Letter RO-6 – Endangered Habitats League

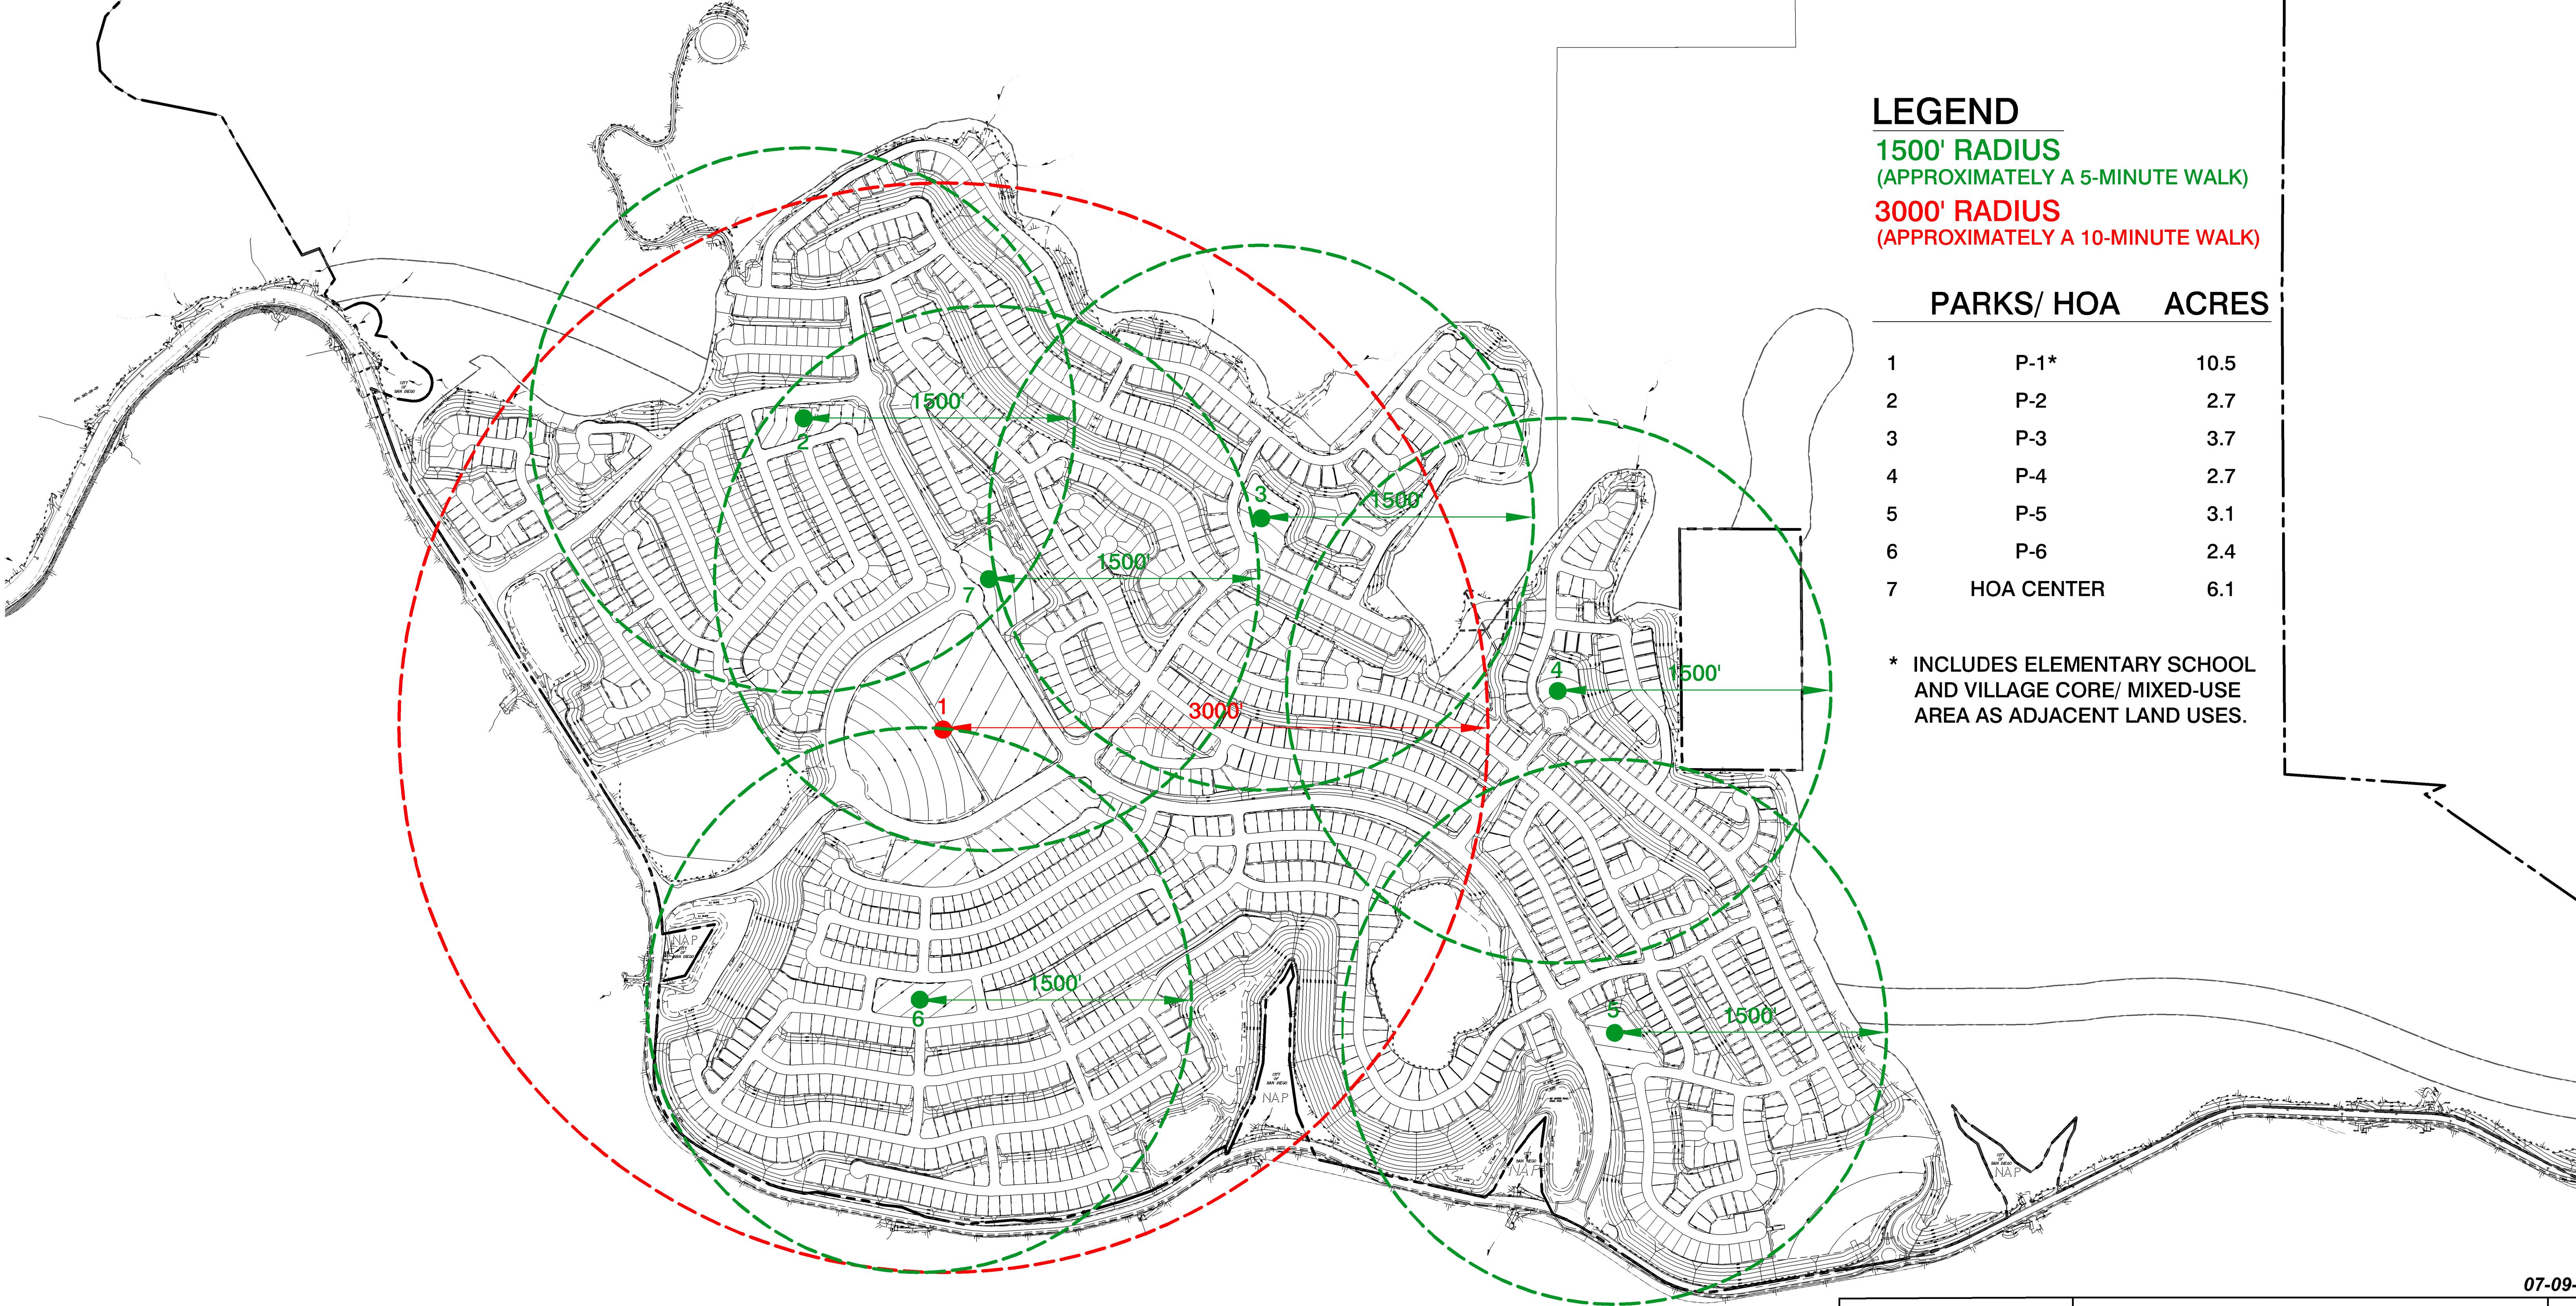
The proposed Project will develop mobility hub features in the Village Core, which includes EV charging stations, ride hailing loading zones, designated micro mobility parking areas, bicycle parking areas for privately owned bicycles. Of note, the Project’s Village Core would be accessible on foot to the majority (80%) of the proposed residential units with an approximately 10-minute walk. This can be seen in the exhibit attached to this Response to Comment as Attachment RO6.2.

Figure 1. Site location and development areas

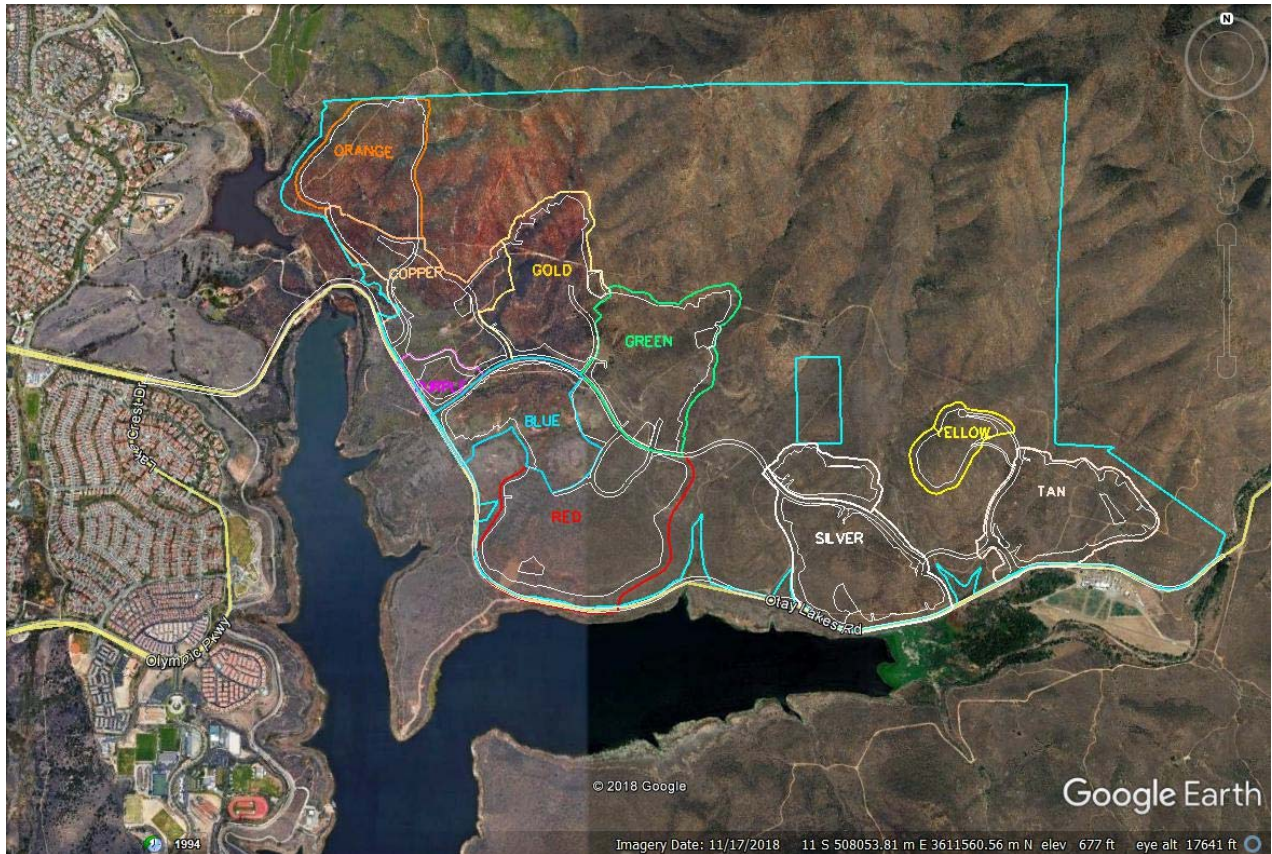
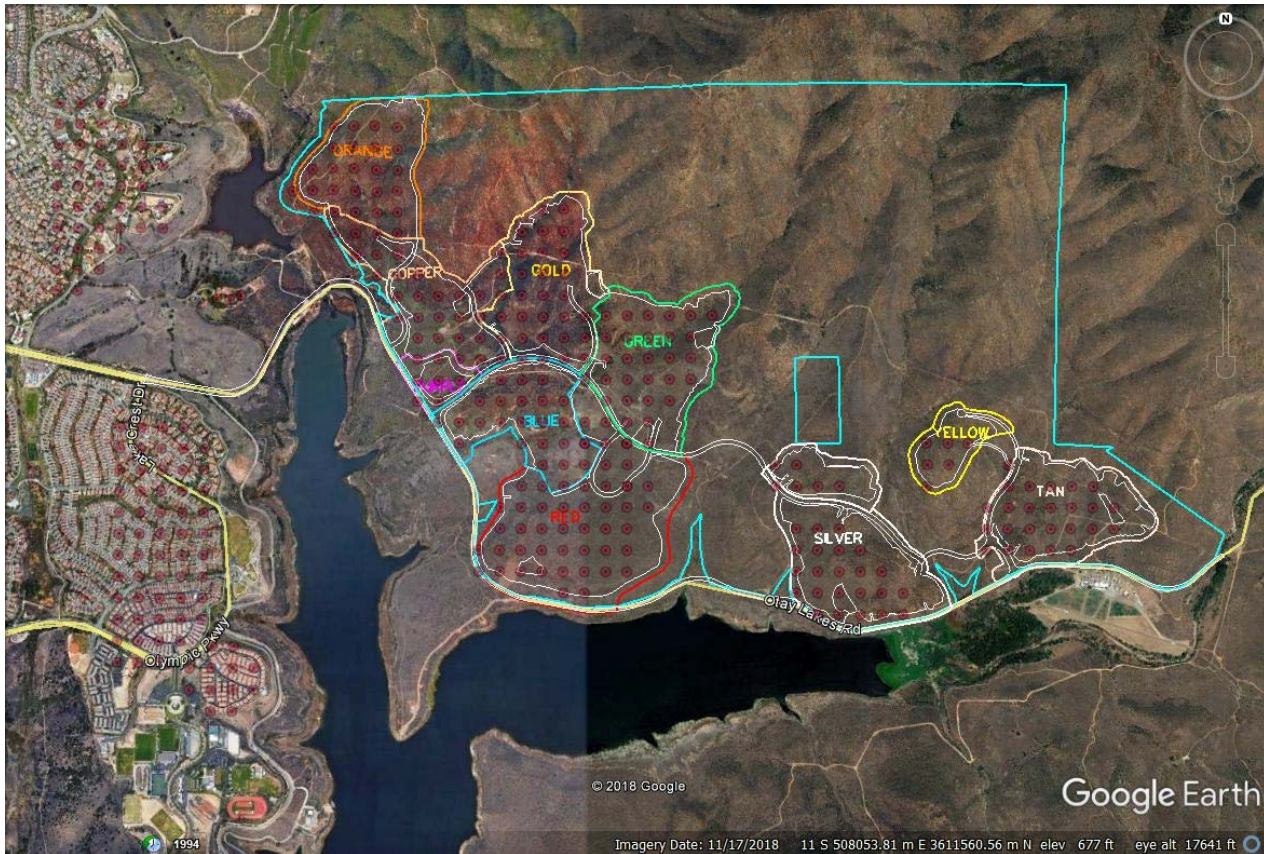
To address the comments on the DEIR, onsite receptors were also included in this analysis. Onsite receptors were placed in a grid over the areas proposed for residential development and the school site. Further discussion of the construction phasing as it relates to onsite receptors is provided in subsequent sections of this Technical Memorandum.

Figure 1 below shows the location of the project and its boundary (see blue line), and project phasing (indicated by various development subphase areas coded with color names). Figure 2 shows the location of the onsite and offsite receptors.

Figure 1. Alternative H site location and development areas

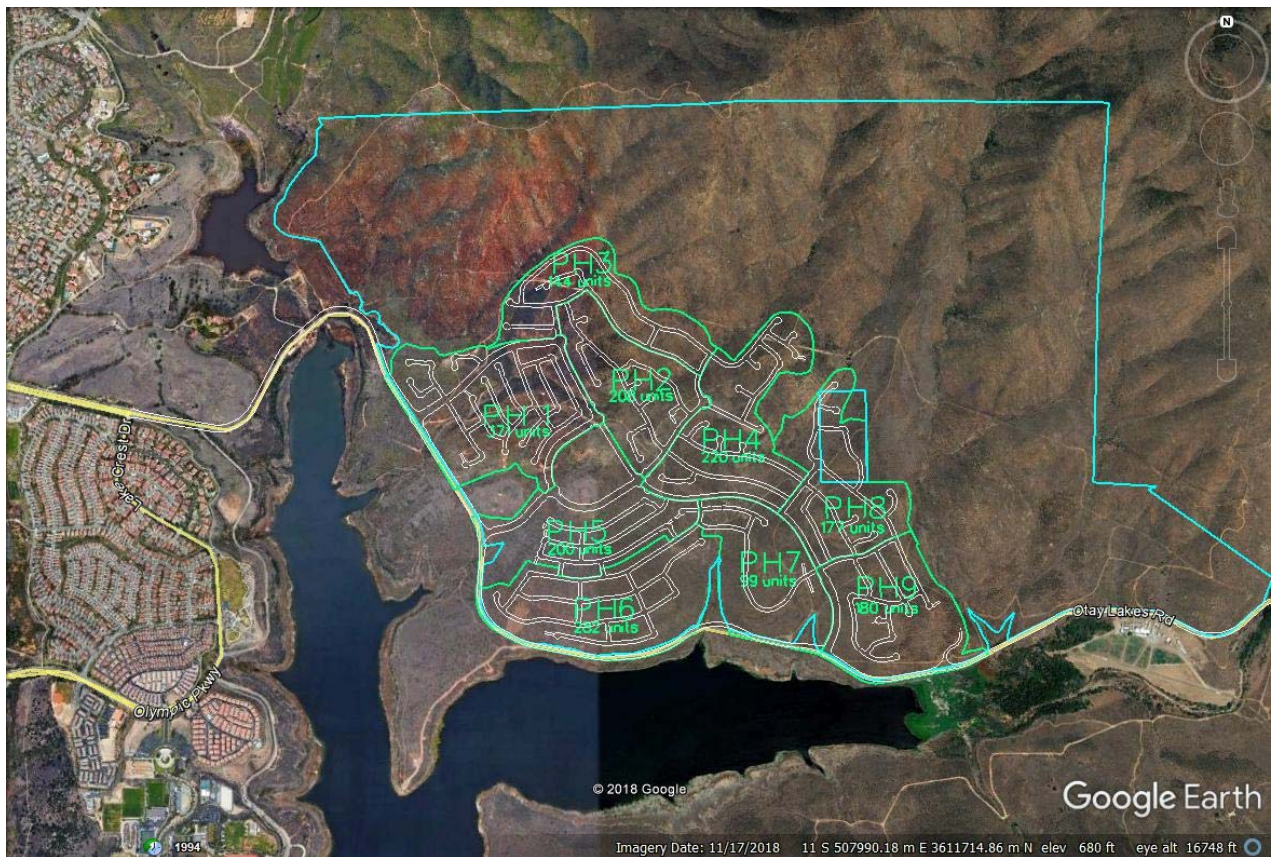
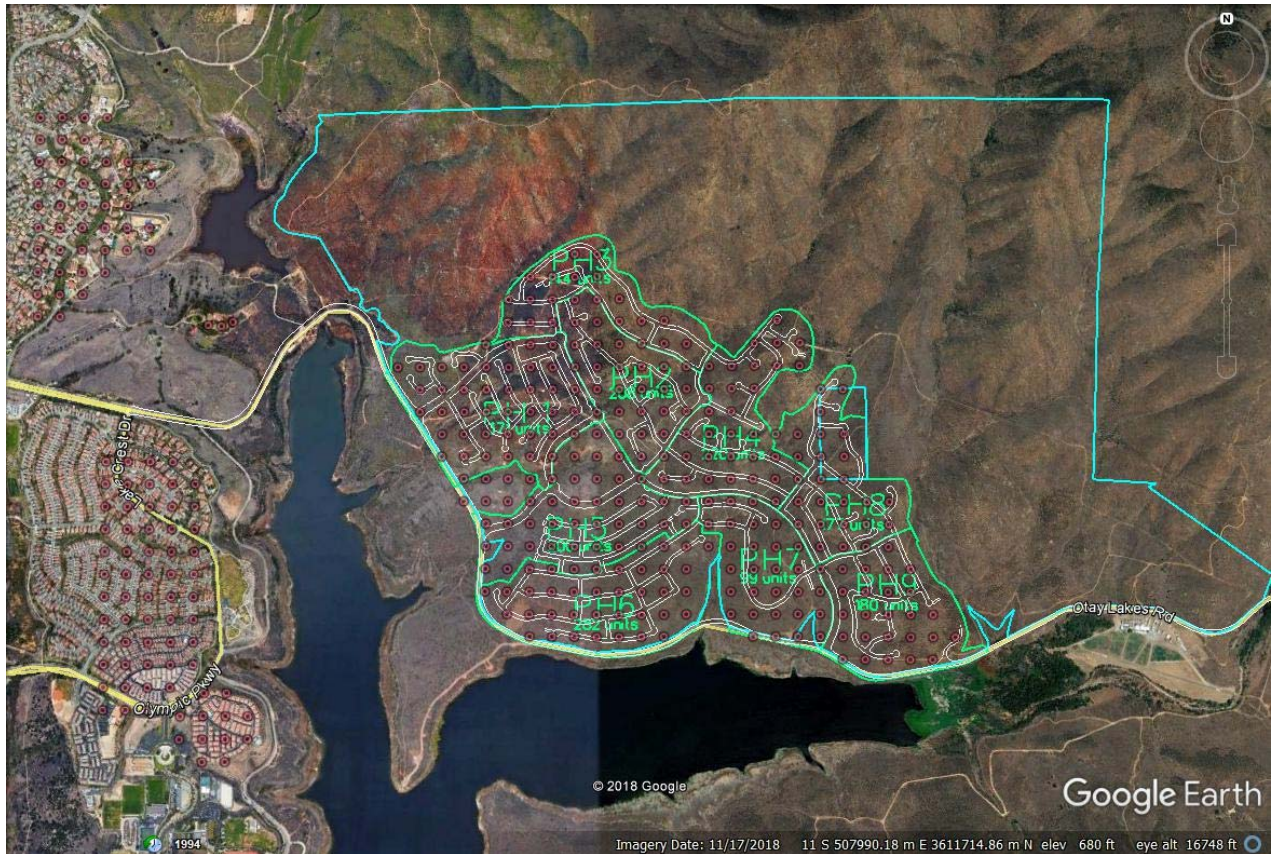
To address the comments on the DEIR for Alternative H, onsite receptors were also included in this analysis. Onsite receptors were placed in a grid over the areas proposed by Alternative H for residential development and the school site. Further discussion of the construction phasing as it relates to onsite receptors is provided in subsequent sections of this Technical Memorandum.

Figure 1 below shows the location of the Project and its boundary (see green line), and project phasing (indicated by various development subphase areas coded with color names). Figure 2 shows the location of the onsite and offsite receptors.
